CITY OF ALBUQUERQUE

May 17, 2022

Re: Panda Express
98th St. NW
Traffic Circulation Layout
Architect's Stamp 05-09-22 (K09-D038)

Based upon the information provided in your submittal received 05-16-22, the above referenced plan cannot be approved for Building Permit until the following comments are addressed:

TC 1.0

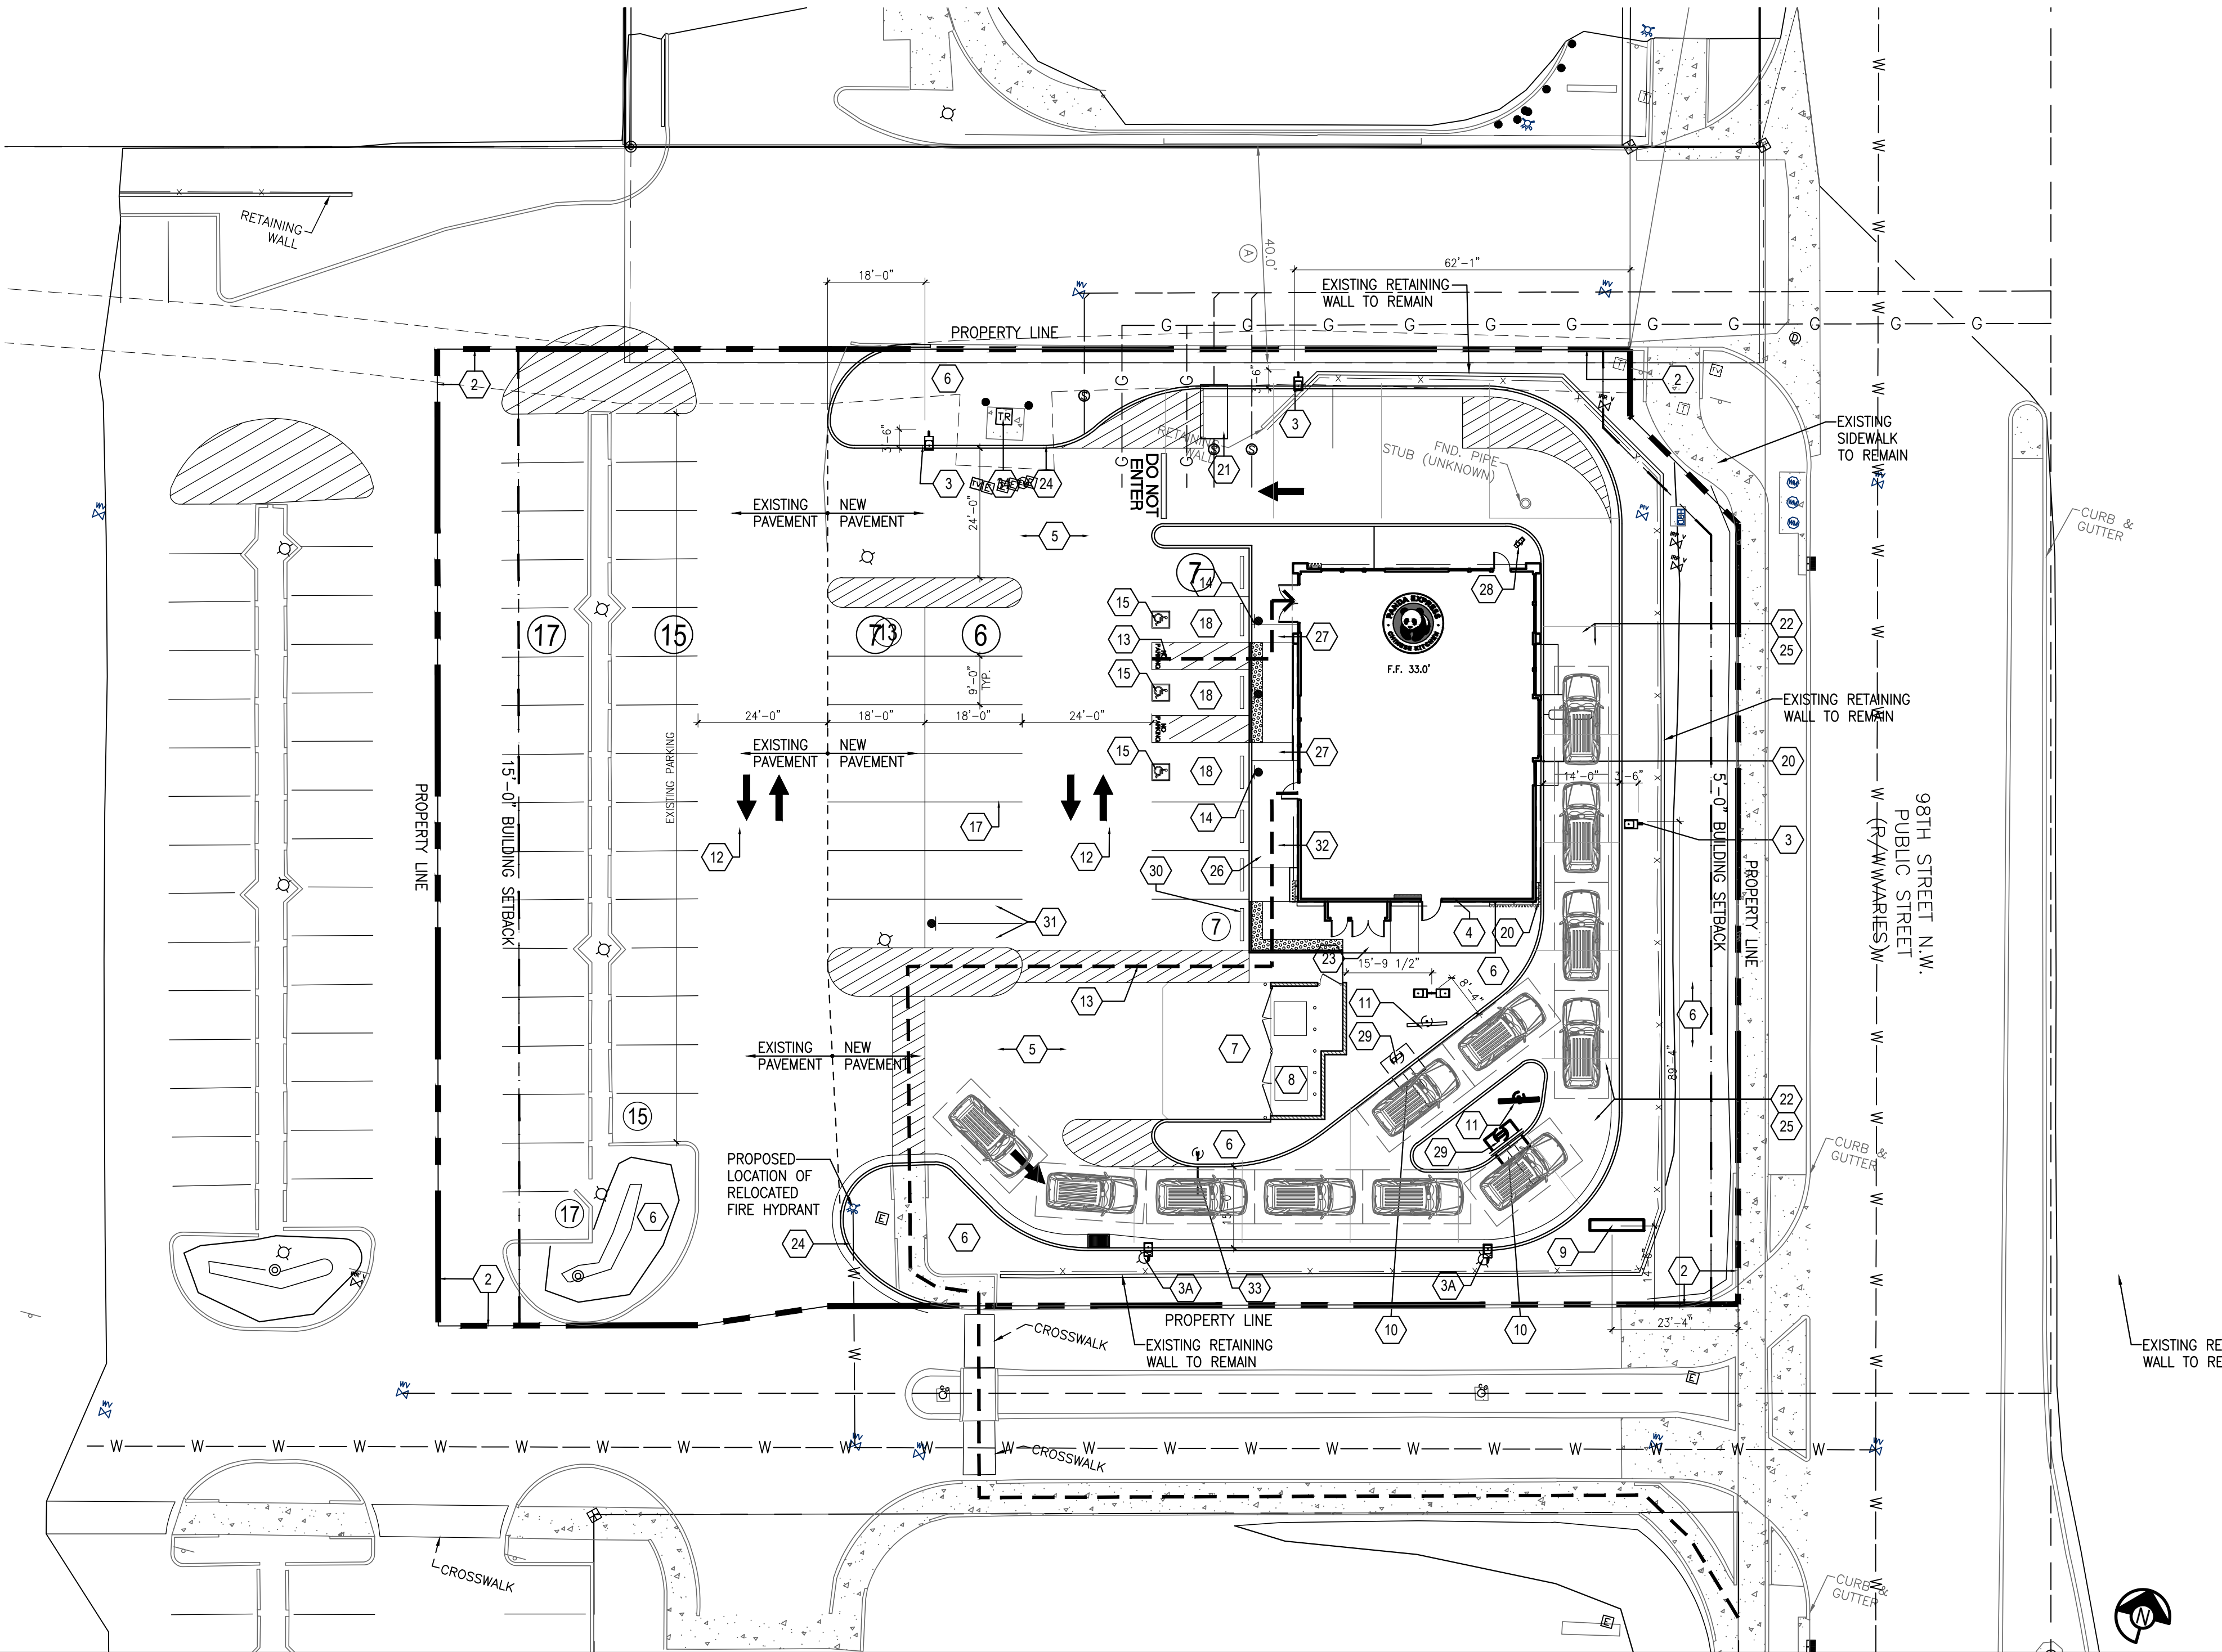
1. Identify the right of way width, medians, curb cuts, and street widths on 98th St. NW.
2. Provide the width for the streets at north side and south side of the site.

3. Provide the number of Bicycle parking spaces required by the IDO.
4. What will separate your site from the street on the north side of your site? Please address this concern.

5. Keynote 27: provide ADA ramp details and reference COA std dwg.
6. Define ADA pedestrian pathway by labeling of ramp, flush pavement and dimensioning of pathway.

7. ADA curb ramps must be updated to current standards and have truncated domes installed.
8. Provide dimensions for the existing parking spaces.
9. The pavement marking "MC" should be shown in the opposite direction for motorcycles entering the parking space.

10. Provide details for "NO PARKING" pavement marking. And provide details for all proposed pavements marking.
11. All one-way drives shall have "One Way" and "Do Not Enter" signage and pavement markings. Please show detail and location of posted signs and striping.

12. The minimum drive through lane width is 12 feet with a 25 foot minimum radius (inside edge) for all turns. (A 15 foot radius can be used with an increase in lane width to 14 feet). Please dimension all lane widths and radii.

13. Please provide a sight distance exhibit
14. Show the clear sight triangle and add the following note to the plan: "Landscaping and signage will not interfere with clear sight requirements. Therefore, signs, walls, trees, and shrubbery between 3 and 8 feet tall (as measured from the gutter pan) will not be acceptable in the clear sight triangle.
